South Texas Project Electric Generating Station 4000 Avenue F - Suite A Bay City, Texas 77414

February 18, 2010
U7-C-STP-NRC-100045

South Texas Project
Units 3 and 4
Docket Nos. 52-012 and 52-013
Response to Request for Additional Information

Attached are the responses to the NRC staff questions included in Request for Additional Information (RAI) letter number 310 related to Combined License Application (COLA) Part 2, Tier 2, Section 9.2. This submittal completes the response to this RAI letter.

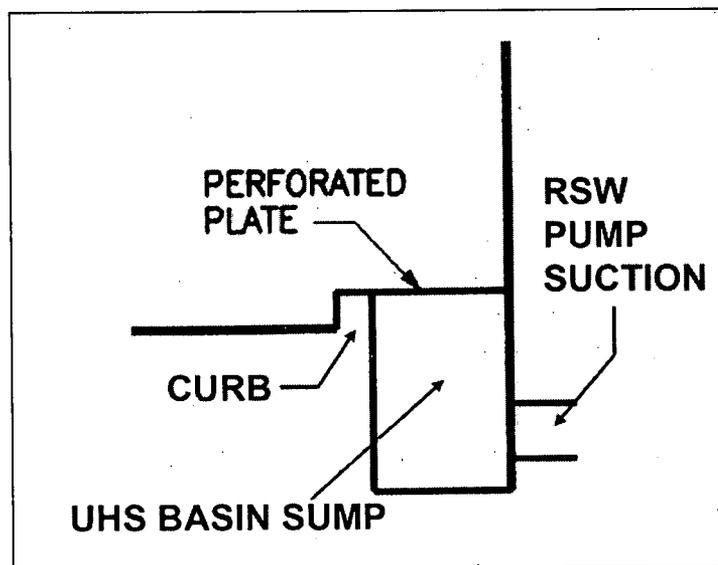
GDC 44 requires reliable operation of the ultimate heat sink (UHS) under all anticipated conditions. In the COL application, Revision 2, different elevations related to the UHS were inconsistently reported. RAI 9.2.5-1 requested that the applicant address the inconsistency that appears in the COL application in regards to UHS water levels. The applicant responded to this RAI in a letter dated August 28, 2009 (Ref: U7-C-STP-NRC-090123). In this response, the applicant stated that the COL application will be modified to make all of the water levels cited within the application consistent. As part of the response the applicant included a new figure to replace COL Tier 2, Figure 1.2-35. However, the curb identified in the COL application, Tier 2, Section 9.2.5.2(5), and also identified in the version of Figure 1.2-35 in revision 2 of the application, has been eliminated from the new Figure 1.2-35. This curb is included to prevent sediment migration to the pump. No justification for the elimination of the curb has been provided. Provide justification for elimination of the curb.

The curb described in COLA Rev. 3, Tier 2, Section 9.2.5.5.2(5), and also identified in COLA Rev. 2, Figure 1.2-35, has not been eliminated from the Ultimate Heat Sink design. The curb exists as depicted below.

No COLA change is required as a result of this RAI response.
